Product Change Notice (PCN)

PCN Number: **PCN-0451162R-01**

Product(s) Affected: PJ-040CH

PREVIOUS CUI DEVICES DETAIL / IMAGE	NEW CUI DEVICES DETAIL / IMAGE

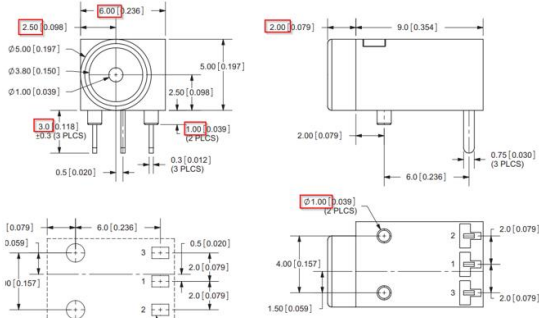
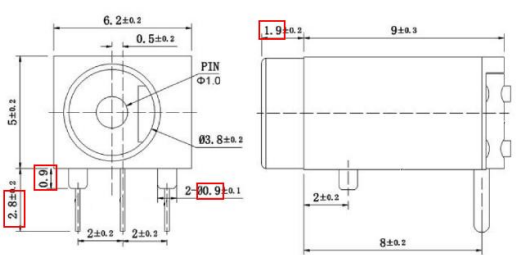
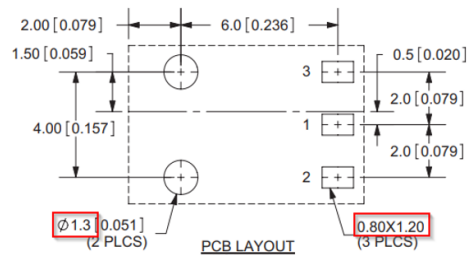
Description of Change: mechanical, material differences as shown below:

<p>PCB LAYOUT TOP VIEW</p>	 <p>Recommended PCB Layout Top View</p>																																							
<table border="1"> <thead> <tr> <th></th> <th>MATERIAL</th> <th>PLATING</th> </tr> </thead> <tbody> <tr> <td>center pin</td> <td>brass</td> <td>silver</td> </tr> <tr> <td>terminal 1</td> <td>brass</td> <td>silver</td> </tr> <tr> <td>terminal 2</td> <td>copper alloy</td> <td>silver</td> </tr> <tr> <td>terminal 3</td> <td>brass</td> <td>silver</td> </tr> <tr> <td>plastic</td> <td>PA66</td> <td></td> </tr> </tbody> </table>		MATERIAL	PLATING	center pin	brass	silver	terminal 1	brass	silver	terminal 2	copper alloy	silver	terminal 3	brass	silver	plastic	PA66		<table border="1"> <thead> <tr> <th>DESCRIPTION</th> <th>MATERIAL</th> <th>PLATING/COLOR</th> </tr> </thead> <tbody> <tr> <td>center pin</td> <td>brass</td> <td>silver</td> </tr> <tr> <td>terminal 1</td> <td>brass t=0.25</td> <td>silver</td> </tr> <tr> <td>terminal 2</td> <td>brass t=0.25</td> <td>silver</td> </tr> <tr> <td>terminal 3</td> <td>brass t=0.25</td> <td>silver</td> </tr> <tr> <td>cover</td> <td>PBT (UL94V-0)</td> <td>black</td> </tr> <tr> <td>housing</td> <td>PBT (UL94V-0)</td> <td>black</td> </tr> </tbody> </table>	DESCRIPTION	MATERIAL	PLATING/COLOR	center pin	brass	silver	terminal 1	brass t=0.25	silver	terminal 2	brass t=0.25	silver	terminal 3	brass t=0.25	silver	cover	PBT (UL94V-0)	black	housing	PBT (UL94V-0)	black

MATERIAL	PLATING																																						
center pin	brass	silver																																						
terminal 1	brass	silver																																						
terminal 2	copper alloy	silver																																						
terminal 3	brass	silver																																						
plastic	PA66																																							
DESCRIPTION	MATERIAL	PLATING/COLOR																																						
center pin	brass	silver																																						
terminal 1	brass t=0.25	silver																																						
terminal 2	brass t=0.25	silver																																						
terminal 3	brass t=0.25	silver																																						
cover	PBT (UL94V-0)	black																																						
housing	PBT (UL94V-0)	black
